Re: **Container Corporation of America**
Proposed Batch Digester and Brown Stock Washer
AC45-190382; AC-45-190383; PSD-FL-165

Re: Container Corporation of America
Proposed Batch Digester and Brown Stock Washer
AC45-190382; AC45-190383; PSD-FL-165

RE: Container Corporation of America, Inc. (PSD-FL-165)

RE: Container Corporation of America, Fernandina Beach
Lime Slaker Systems Configuration change AC45-141878

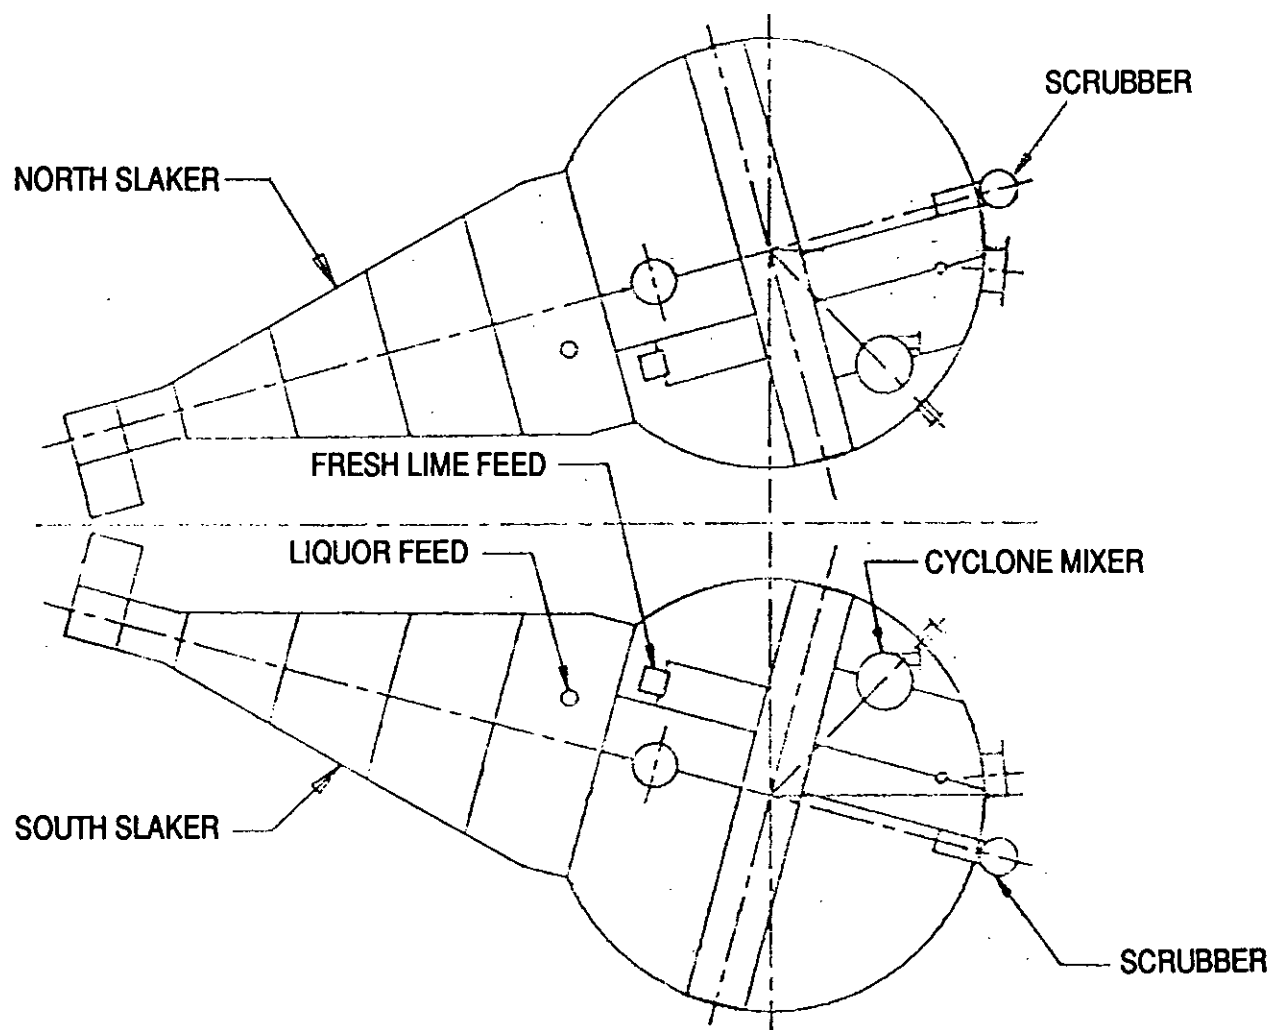
Basically, the only change that has been made by CCA to the two lime slaking systems is that the exhaust gases from each slaker scrubber, instead of discharging through a stack to the atmosphere, drain through a vertical pipe along with the scrubber water to a u-drain and then discharge directly to a mill sewer. As a result, there are no air emissions from the lime slaking systems. Mr. Andy Kutyna of the FDER Northeast District concurred with this conclusion during his recent plant visit.

Attached are three figures. The first shows the revised configuration of the slaker scrubbers exhaust. The remainder of the causticizing system has not changed. The second drawing shows the location of each scrubber on the two slakers, and the third drawing shows a detail view of each scrubber.

The Department has reviewed your letter received February 26, 1990, regarding the two lime slaker systems and their as built configurations, which are different from what was received and permitted. In order to remove the lime slakers (2) from any permitting requirements, please have the P.E. of record submit revisions of the pertinent documents (i.e., plans, drawings, etc.), reflecting the changes that have been made from the original submittal. Upon receipt of this material, an amendment will be made to the referenced construction permit to remove the two lime slakers from permitting requirements at this time..
